Access Compliance Report

Public Rights-of-Way

Intersection ID: 18282	Main Street: RAMA_RD	Cross Street: RIVIERE_DR	Location: NW
ADA ID: 415659CE4D25	Ramp Type: PerpDiag	Initial Pass/Fail: Fail	Overall Compliance: No
Severity Score: 33.75			
Codes/Mitigation Info/Possible Solution		Field Measurements/Component Compliance

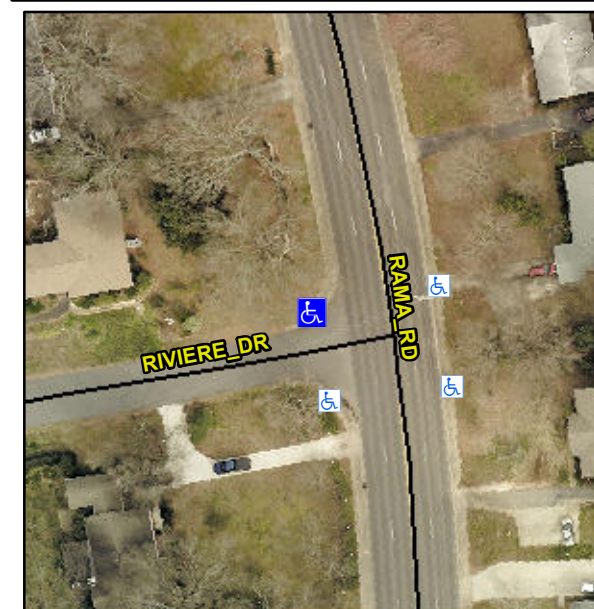
Not Found, R304.5.1, R304.2.2, R304.5.3

Compliance	Description	Data	Compliance	Description	Data
N/A	Ramp Length (in)	60.0	No	Ramp Slope (%)	9.8
No	Ramp Width (in)	44.0	No	Ramp XSlope (%)	5.3
N/A	Flare Type LT	N/A	N/A	Flare Type RT	N/A
N/A	Flare Slope LT (%)	N/A	N/A	Flare Slope RT (%)	N/A
N/A	Flare Traversable LT?	N/A	N/A	Flare Traversable RT?	N/A
N/A	Landing Length (in)	N/A	N/A	DWS Provided?	N/A
N/A	Landing Width (in)	N/A	N/A	DWS Contrast?	N/A
N/A	Landing Slope (%)	N/A	N/A	DWS Length (in)	N/A
N/A	Landing X Slope (%)	N/A	N/A	DWS Full Width?	N/A
N/A	Landing Curb? (Y/N)	N/A	N/A	DWS Offset (in)	N/A
N/A	Shared Landing?	N/A			
N/A	Gutter Ponding?	N/A	N/A	Gutter Slope (%)	N/A
N/A	Gutter Lip Ht (in)	N/A	N/A	Gutter X Slope (%)	N/A
N/A	Painted X Walk1?	No	N/A	Painted X Walk2?	No
	X Walk 1 Direction	To S		X Walk 2 Direction	To E
N/A	X Walk 1 Width (in)	N/A	N/A	X Walk 2 Width (in)	N/A
	X Walk 1 Slope (%)	3.5		X Walk 2 Slope (%)	0.3
	X Walk 1 X Slope (%)	3.5		X Walk 2 X Slope (%)	6.7

Remove & Replace Curb Ramp With Two New Directional Ramps or Equivalent.
